Subject: For U.S. NRC Approval - Proposed Revision 03 to the AREVA Federal Services
Quality Assurance Program Description / U.S. NRC QA Program Approval No. 71-
0938

**Summary of Changes Incorporated
Proposed Revision 03 – AFS Quality Assurance Program Description
(Page 1 of 2)**

Document Number: AFS-QA-PMD-001

Document Title: QUALITY ASSURANCE PROGRAM DESCRIPTION

Figure 1-1

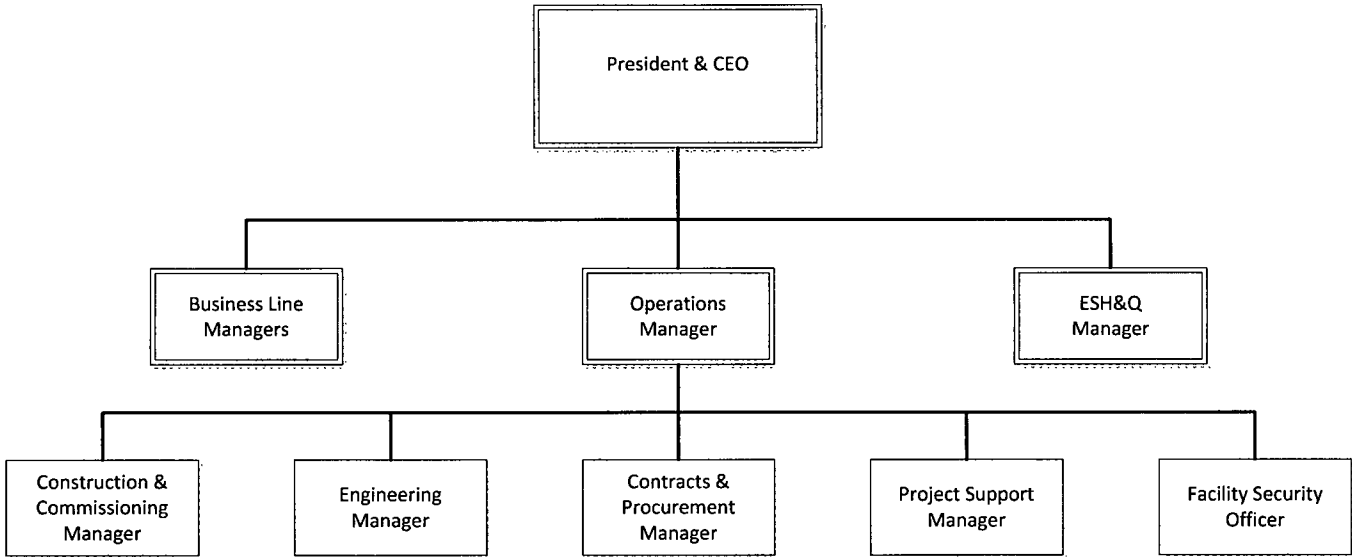
3. Section 1 – Editorial changes and restructuring of information throughout without change of intent.
4. Section 1 – Completely revised the organization responsibilities statements in paragraph 1-202 and replaced the Figure 1-1 to simplify organization statements and describe only those management positions that have responsibilities under the program.

1-202	Completely revised based on new organization structure
	1-203	Editorial changes with no change in intent
	1-204	Added to identify use of generic titles
	Figure 1-1	Completely revised based on new organization structure
	2-100	Editorial changes and added reference to RG 7.10 and NUREG CR/6407 for applying the program in a graded fashion to activities subject to Part 71/72
	2-103	Completely revised to point to Statement of Quality Policy and Authority for the listing of codes, standards, and regulations
	2-200	Editorial changes with no change in intent
	2-201	Editorial changes with no change in intent
	2-300	Revised to improve readability with no change in intent
	2-301	Revised to improve readability and more accurately define the basis for qualification of NDE personnel
	2-302 to 2-500	Editorial changes to improve readability with no change in intent
	2-600	Revised completely to remove the level of specificity
